2021-02-25

REQUEST FOR QUOTATION
BUILDING ENVELOPE REHABILITATION AT AMERICAS
PAVILION – BELVEDERE ROOF AND INTERIOR
TZC T 05-2021-02
ADDENDUM #3

This addendum shall be incorporated into, and form part of TZC T 05-2021-02 and take precedence over all requirements of the previously issued bid documents including plans. This addendum must be signed by the bidder (signing officer) in the appropriate space and must be attached to the Form for submission by the bidder. This Addendum consists of four (4) pages.

SCALE: AS NOTED
 DATE: 2019/08/16
 DWG.#: D6
 REV.#: REV01

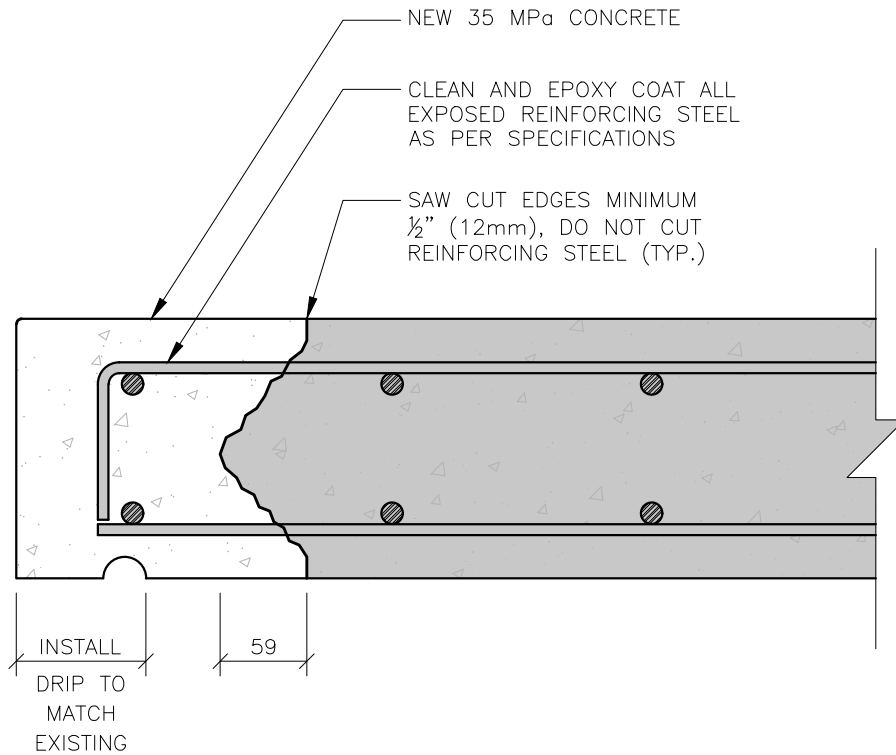
SHEET NUMBER	SHEET NAME	ISSUE DATE
D6 – REV 01	THROUGH SLAB CONCRETE REPAIRS	2021-02-25
